Response to

Request for Additional Information No. 4, Revision 0

U. S. EPR Standard Design Certification

Docket No. 52-020

Figure 19-52-1—Event Tree used to Evaluate Annulus Flood Sequences

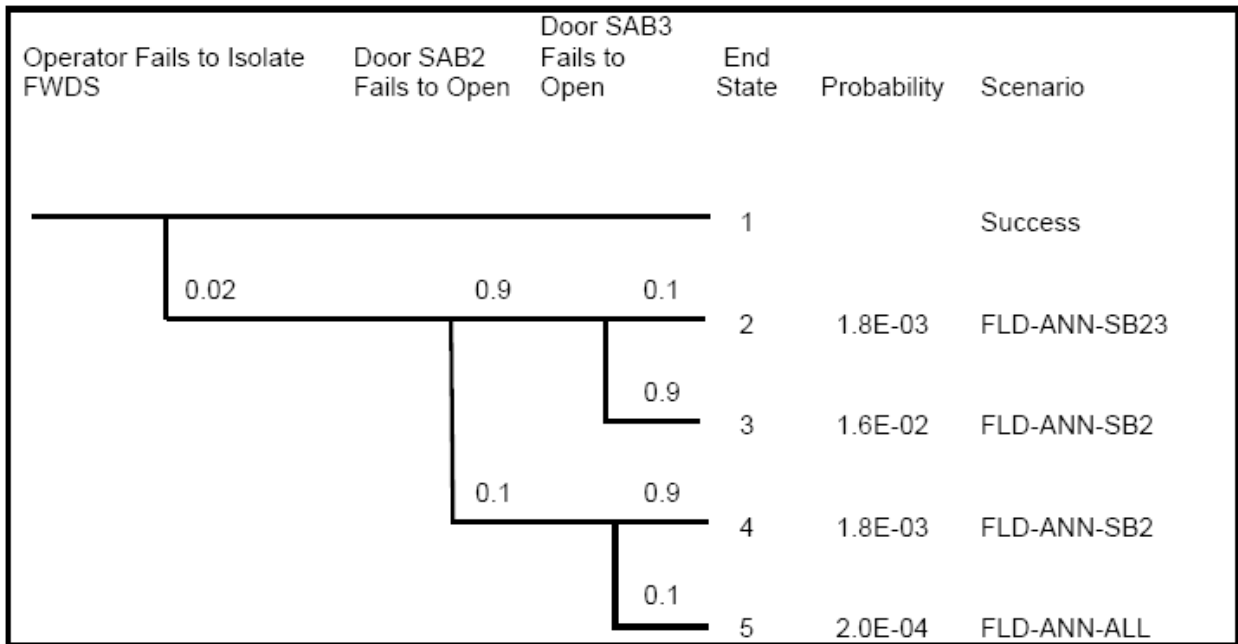
The following findings and questions relate to the reactor building (RB) annulus flooding scenario.

- a. End State 4 of RB flooding event tree (ET) should be named as FLD-ANN SB3.
- b. Describe the consequences of End States 2, 3, and 4 and the contributions of these sequences to the total flooding CDF/LRF.
- c. What is the initiating flooding frequency of this ET?
- d. What are the elevations of the SB2 door, SB3 door, and connection boxes?
- e. What are the probability values of top events “Door of SB2 Fails to Open” and “Door of SB3 Fails to Open”?
- f. What is the probability of “Operator Fails to Isolate FWDS”?
- g. The probability that the connection boxes to the containment would fail if submerged is estimated to be 0.5. If the state of knowledge regarding the penetration design is limited and if these boxes are not watertight, the higher failure probability of 1.0 should be assigned.

It is correct that End State 4 results in SB 3 being flooded due to flood propagation from the Annulus. However, due to the symmetry between SB 2 and SB 3, the same flood scenario, FLD-ANN SB2, is used to model flood propagation to SB 2 and in SB 3. The frequency for this scenario is a sum of the flood frequency in SB 2 and the flood frequency in SB 3. Therefore, FLD-ANN SB2 is a designated scenario for FLD-ANN SB3.

End States 2, 3 and 4 are evaluated in two different flooding scenarios:

1. End State 2 corresponds to the flood scenario FLD-ANN-SB23: All safety systems in SB 2 and SB 3 are assumed to be disabled by the flood. The CDF due to this scenario is smaller than $1E-12/\text{yr}$, and the contribution to the total flooding CDF/LRF is negligible.
2. End States 3 and 4 correspond to the flood scenario FLD-ANN-SB2, as discussed in response 19-52a above: All safety systems in SB 2 are assumed to be disabled by the flood. The CDF due to this scenario is smaller than $1E-11/\text{yr}$, and the contribution to the total flooding CDF/LRF is negligible.

Available time is conservatively based on the time to reach Elevation +0' which is estimated to be 30 minutes. A delay time of 3 minutes is assumed to trigger the sump alarm.

This probability is also shown in Figure 19-52-1
